Document Update Notification

DOCUMENT NO: OP-1903.004

TITLE: ADMIN. & MAINTENANCE OF THE
EMERGENCY PLAN & IMPLEMENTING
PROCEDURES

CHANGE NO: PC-03

ATTACHMENT 1

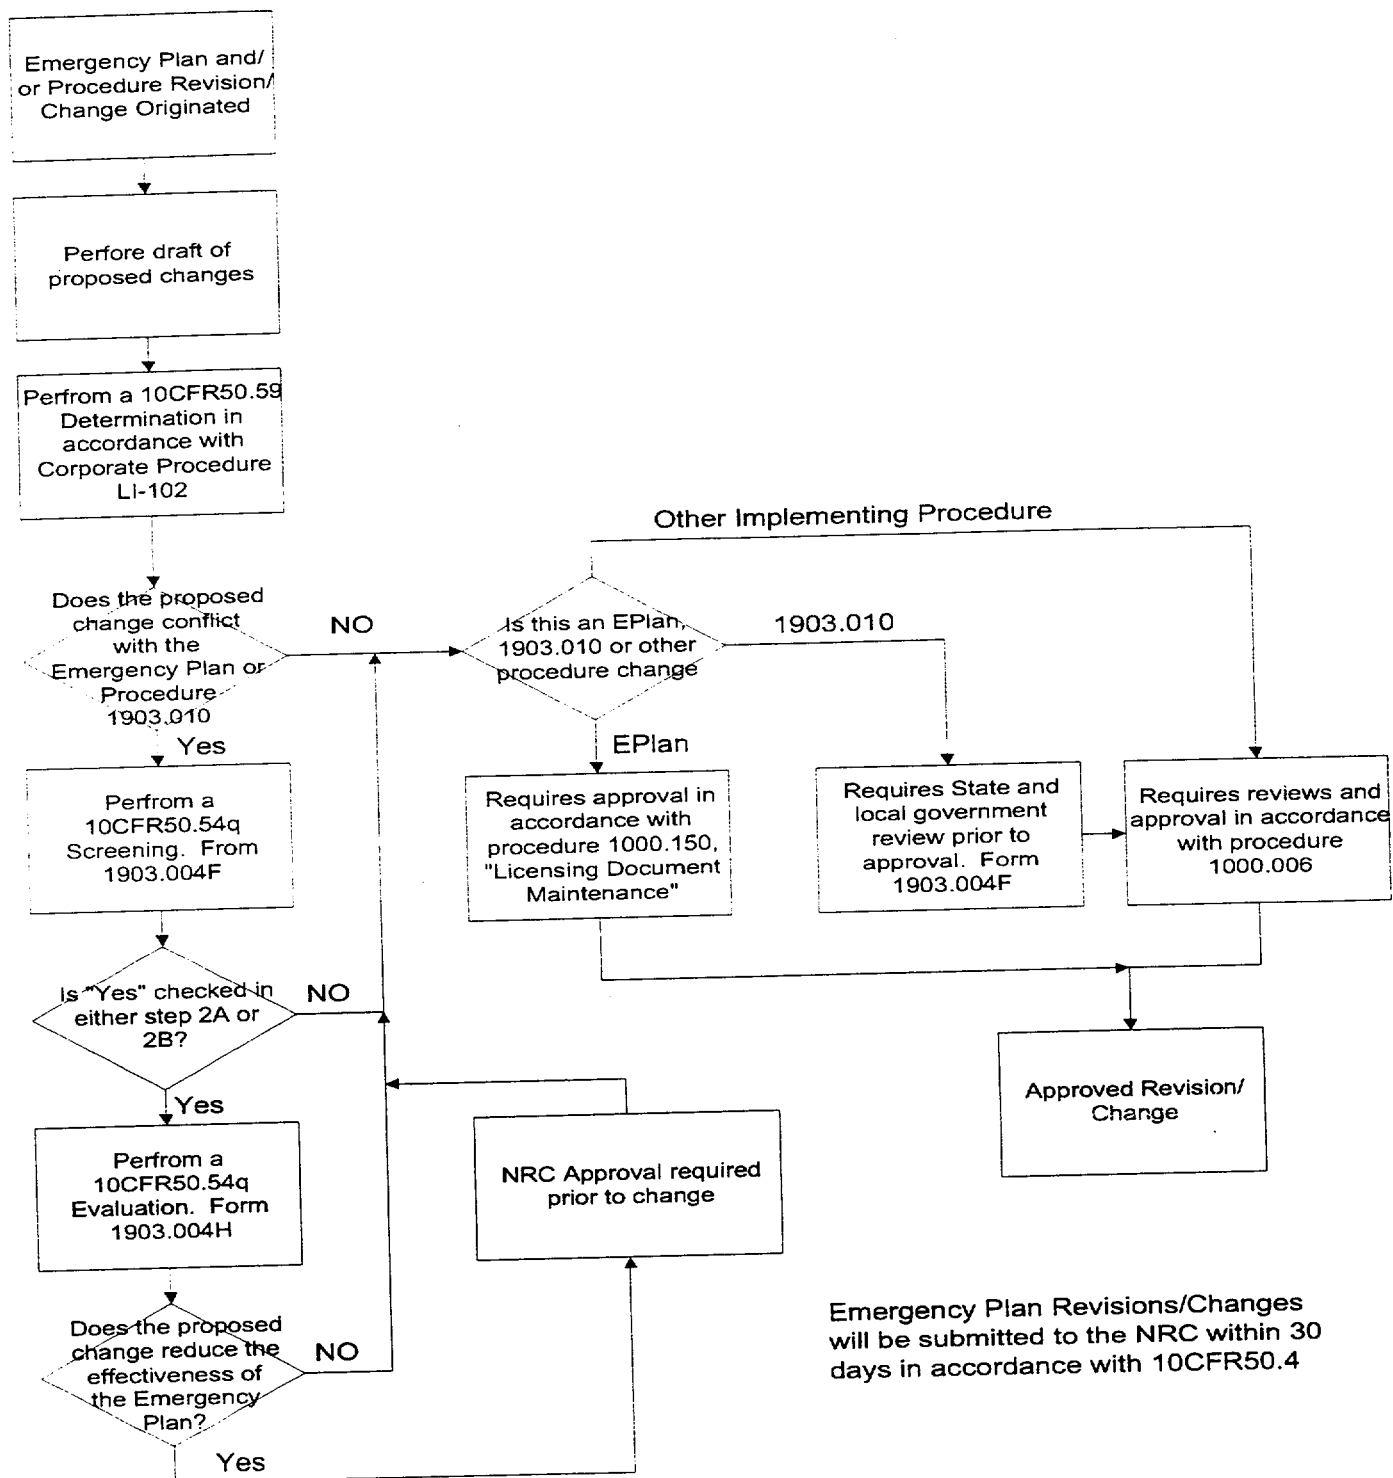
Deleted old chart and added new chart.
